MSLA 1-D LANDFILL

SITE IMPROVEMENTS PROJECT

KEARNY, NEW JERSEY

– RECORD Drawings –

STATION 61+00

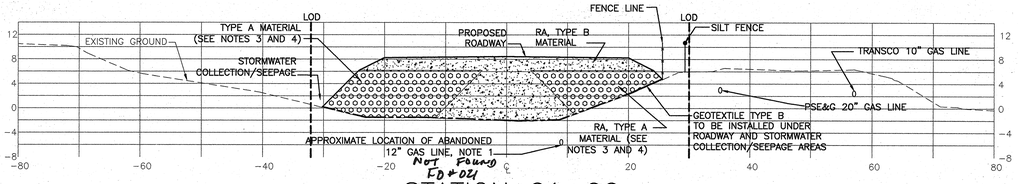
6. THE THICKNESS OF RA TYPE A MATERIAL WILL VARY BETWEEN STATIONS 60+00 AND 63+00.
7. RA, TYPE A MATERIAL SHALL NOT BE USED AT STATION 50+00.

No.	DATE	REVISION
C		
B	06/02/09	REV. STATION 61+00 & NOTE 7 ADDITION
A	04/03/09	ISSUED FOR CONSTRUCTION

STATION 70+00

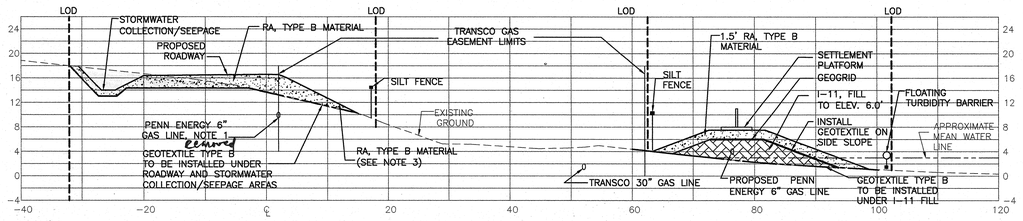
5. TO PROVIDE STABILITY TO THE GAS PIPELINE FILL AREA, CONTRACTOR SHALL INSTALL GEOGRID TO DEPTHS AS DIRECTED BY THE ENGINEER.
6. GEOGRID SHALL BE INSTALLED TO A WIDTH OF 12.5 FEET CENTERED OVER AND ALONG THE 6" GAS PIPELINE, AND THE GEOGRID SHALL BE INSTALLED BELOW THE GEOTEXTILE, TYPE B.

No.	DATE	REVISION
C		
B	07/28/09	REV. STATION 70+00 & NOTE 6 ADDITION
A	04/03/09	ISSUED FOR CONSTRUCTION

5/20 CONDENSATE PIPE/ELECTRICAL CONDUIT DETAIL
SCALE: AS NOTED

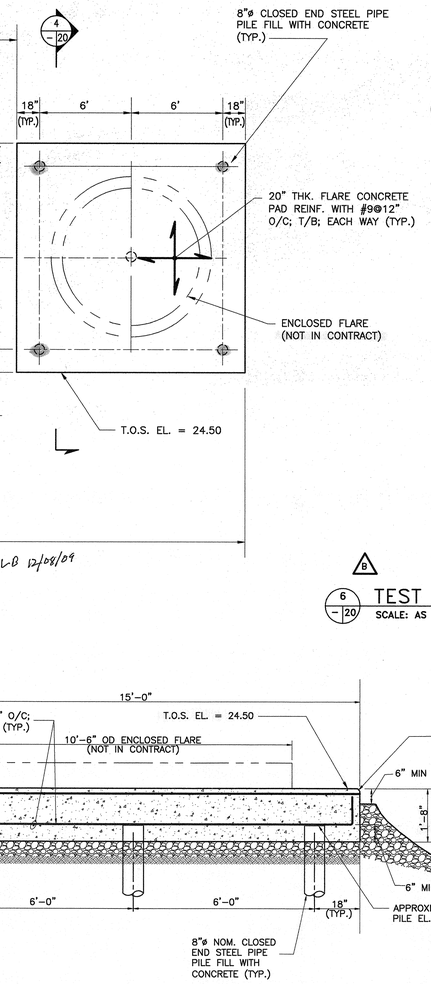
B 6/20 TEST STATION & MAGNESIUM RIBBON ANODE INSTALLATION
SCALE: AS NOTED

No.	DATE	REVISION
C		
B	06/02/09	REV. – ANODE DETAIL
A	04/03/09	ISSUED FOR CONSTRUCTION
